Urgent Field Safety Notice

Neuromate Stereotactic System Neuroinspire – neurolocate module Incorrect images in the IFU

FSN Ref: VR-23-12.1

Details of the correct and incorrect images are detailed below:

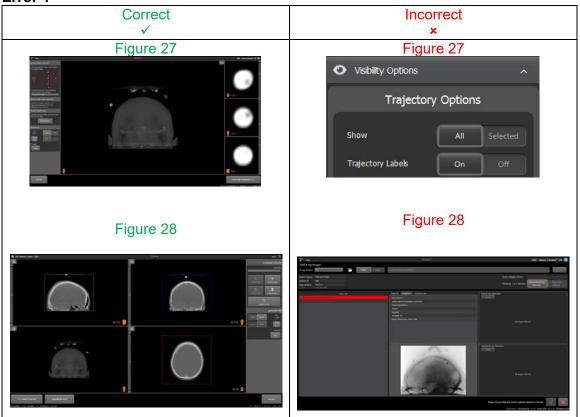
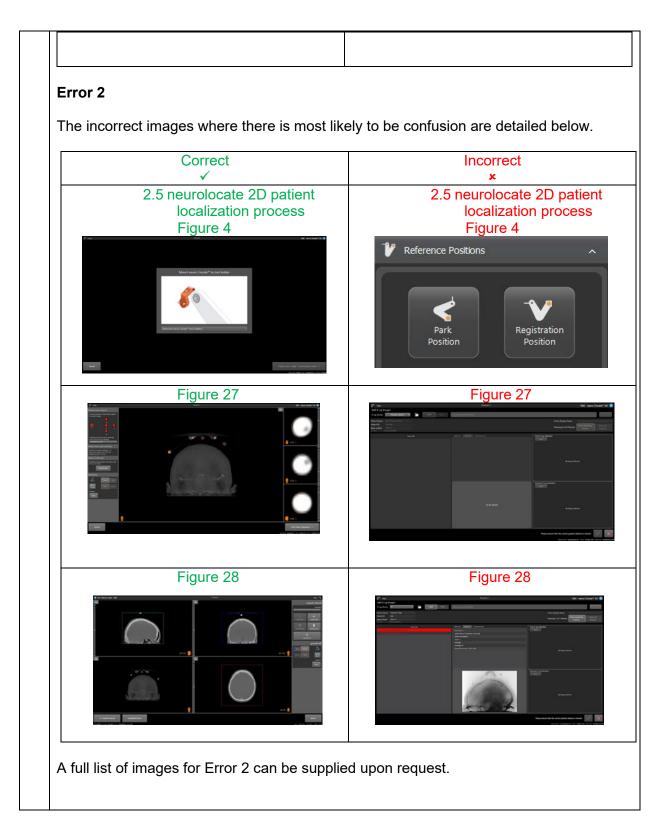
Some of the images in the IFUs are incorrect and do not relate to the corresponding text in the IFUs.

Section 3.8 – Figure 27 Section 3.9 – Figure 28

Figures 27 & 28 are images which are neurolocate module specific. The text is clear on the actions required, the images should give the expected view on the screen. The software user interface and the text in the IFU are sufficient for the surgeon to continue the surgery with no harm to the patient.

The correct images are presented below and provide the correct view on the screen

3.		Is customer Reply Required yes, form attached specifying		No			
3.	_	5. Action Being Taken by the Manufacturer*					
		□ Product Removal□ Software upgrade□ Other	□ On-site device mod☑ IFU or labelling cha□ None	•			
		The images in the IFUs cite affected sites.	ed in section 1 will be updated a	and new IFUs provided to
